Permit # _____ City of Portland BUILDING PERMIT APPLICATION Fee \$3445 Zone _____ Map # _____ Lot# _____
Please fill out any part which applies to job. Proper plans must accompany form. \$300 - major site plan

October 6, 1993

Re: 27 Riverside St

**CITY OF PORTLAND, MAINE
SITE PLAN REVIEW
Processing Form**

PROJECT TITLE
 PROPOSED RETAIL FACILITY
**VIP DISCOUNT
 AUTO CENTER**
 RIVERSIDE STREET
 PORTLAND, ME
 FOR
 OPECHEE
 CONSTRUCTION MANAGEMENT CORP.
 21 PRODUCTION PLACE UNIT 4
 GILFORD, NH

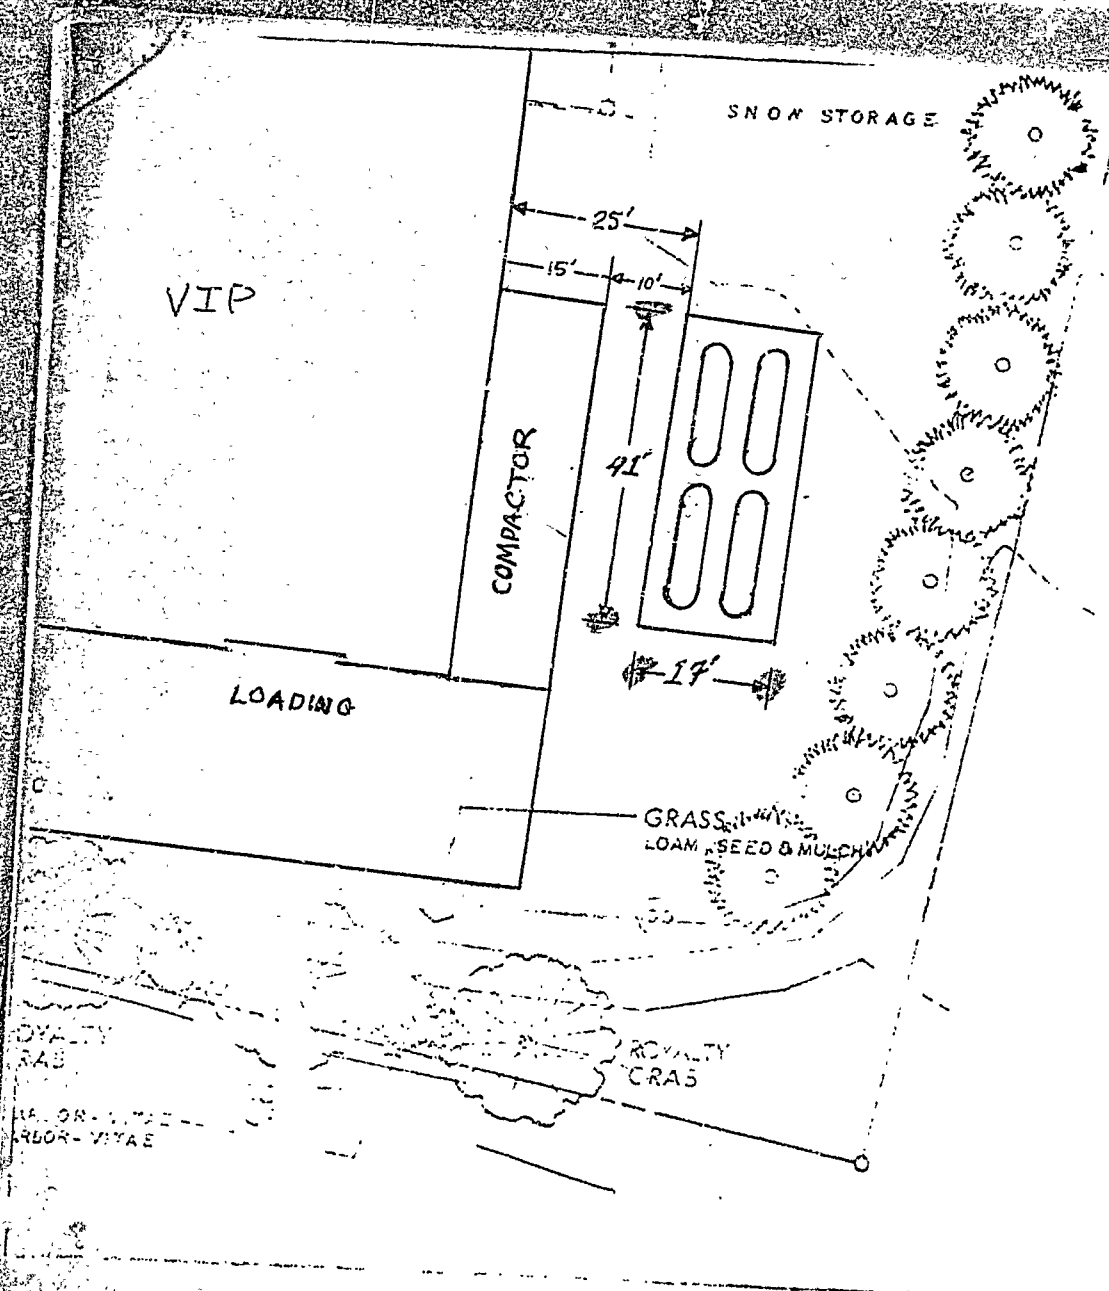
*SEE VISITING
 SEWER PLAN
 TRANK ATTACHED
 12/1/93*

RED PINE
 15 O.C. MIN. 6' HIGH (TYP.) 6/Dec/93
 Revised site
 For Tanks.

D/F Internally Illuminated Pylon with
Electronic Message Display
3/8"=1'-0"

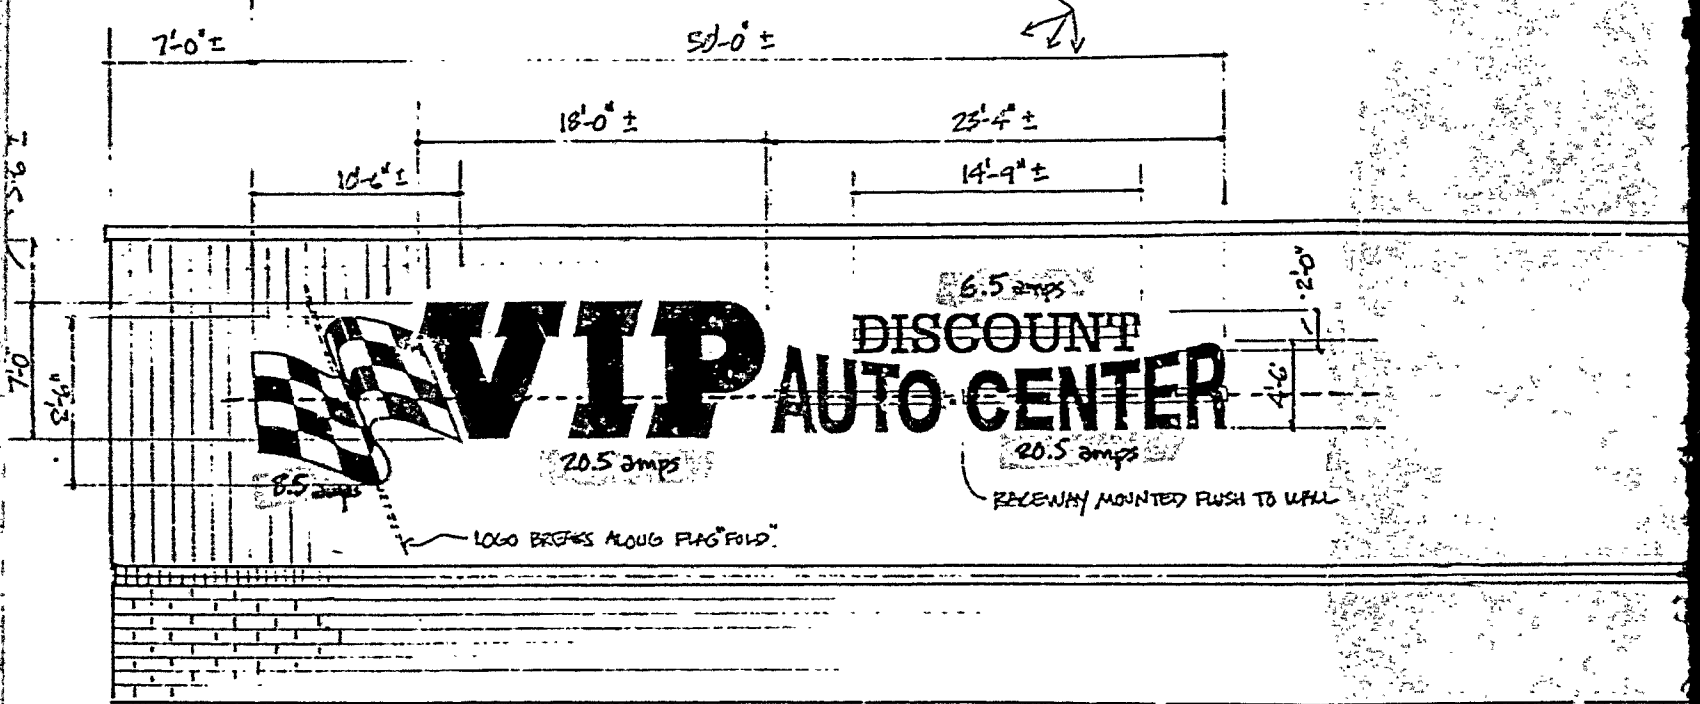
change
to
